PROJECT DESIGN DOCUMENT (PDD)

Title of the project activity: Lebong Hydroelectric Power Plant

Version number of the PDD: Version 3.42

Completion date of the PDD: ~~23/11/2014~~ 206/04/2015

Figure B.7.2.1 Indicative grid connection diagram

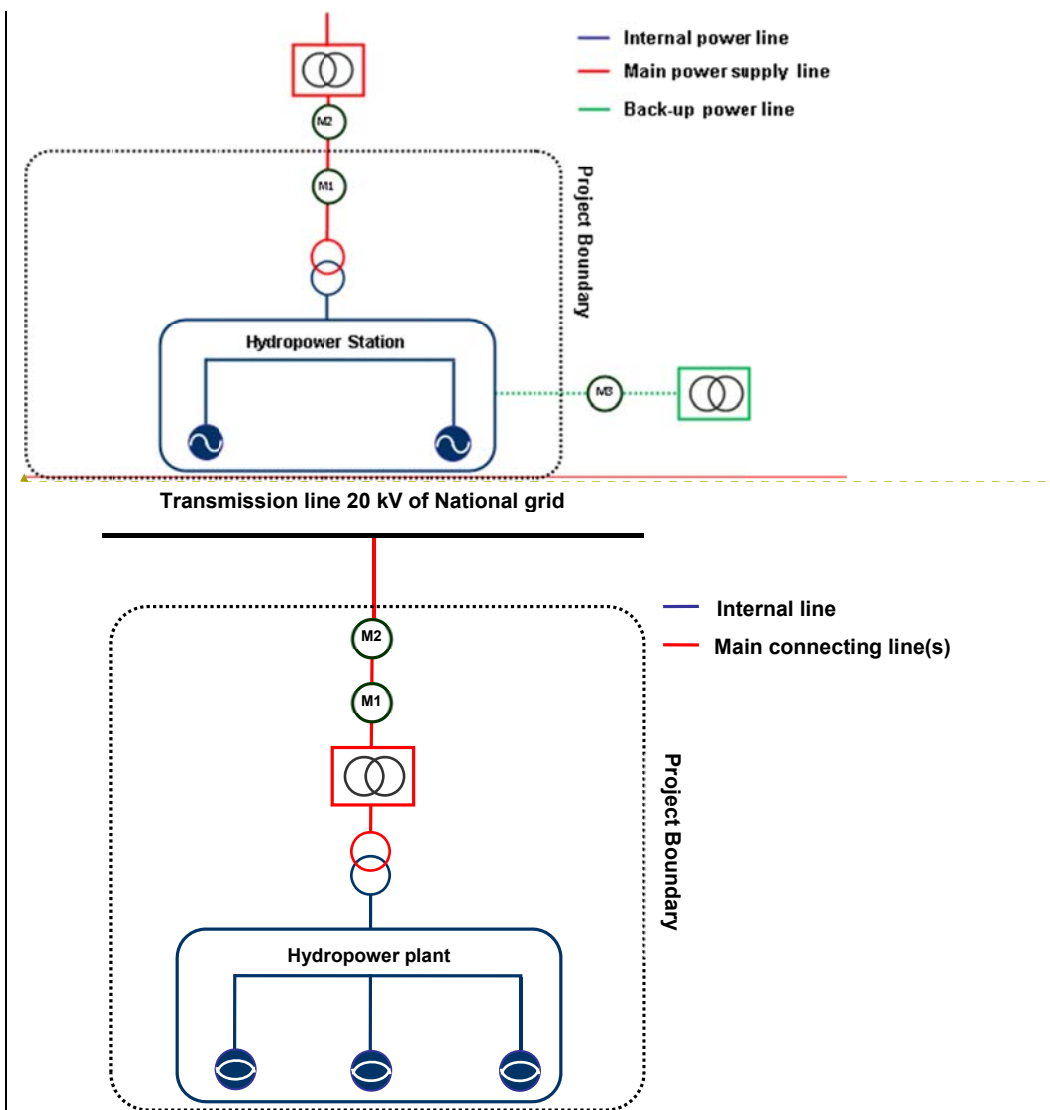
~~As indicated in Figure B.7.2.1 the project may be connected by a back-up emergency power line (indicated in dotted green straight line) which delivers power from the grid to the project in case of emergencies or when the turbines of the proposed project activity are not in operation. Net power received from the grid is metered as below:~~

1. The type of meters installed in the plant measuring the electricity exported to the Grid has been incorrectly mentioned as bidirectional meters instead of one directional meters, which has been corrected in the monitoring report. There is no electricity imported from the Grid in case of emergencies or when the turbines of the proposed project activity are not in operation, i.e. the backup power line (via M3) figured in green dotted line in the Figure B.7.2.1 of the registered PDD does not exist in the reality. In case of emergencies, the project will use the power generated from backup diesel generator for auxiliary maintenance activities such as welding, repairing etc.

Figure B7.2.2 Management structure in order to monitor emission reductions

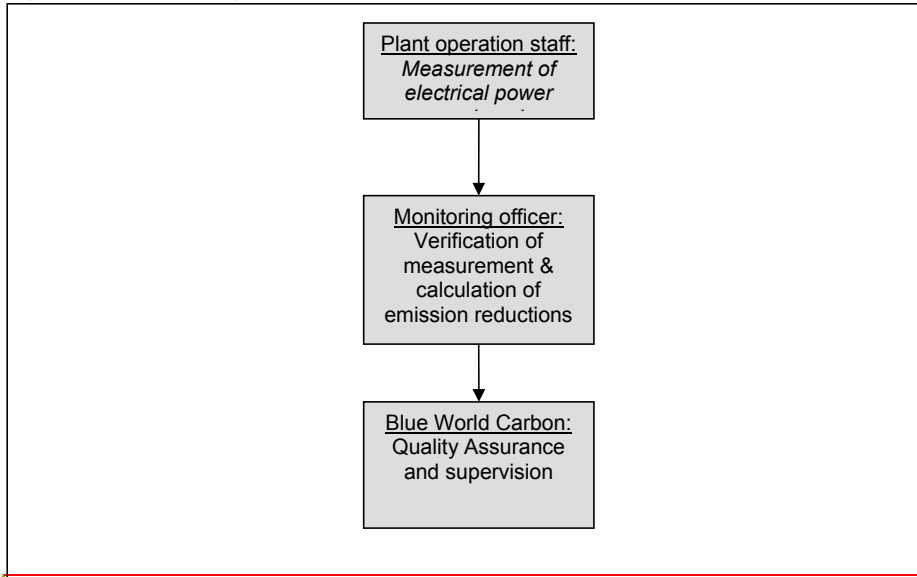
~~The project entity will engage its CDM advisor, Blue World Carbon to assure that all monitoring requirements are met. Within the project entity a monitoring officer is appointed who will carry the day-to-day supervision responsibility. The first step is the measurement of the electrical energy supplied to the grid and reporting of daily operations, which will be carried out by the plant operation staff.~~

~~The monitoring officer who will be responsible for verification of the measurement, collection of sales receipts, collection of billing receipts of the power supplied by the grid to the hydropower plant and the calculation of the emissions reductions. The monitoring officer will prepare operational reports of the project activity, recording the daily operation of the hydropower station including operating periods, power delivered to the grid, equipment defects, etc. The selection procedure, tasks and responsibilities of the monitoring officer are described in detail in Annex 4. Finally, the monitoring reports will be reviewed by Blue World Carbon.~~

The operational and management structure for monitoring of the project has been corrected according to the actual organization established to manage and monitor the project in section B.7.3 of revised PDD (version 03.2).
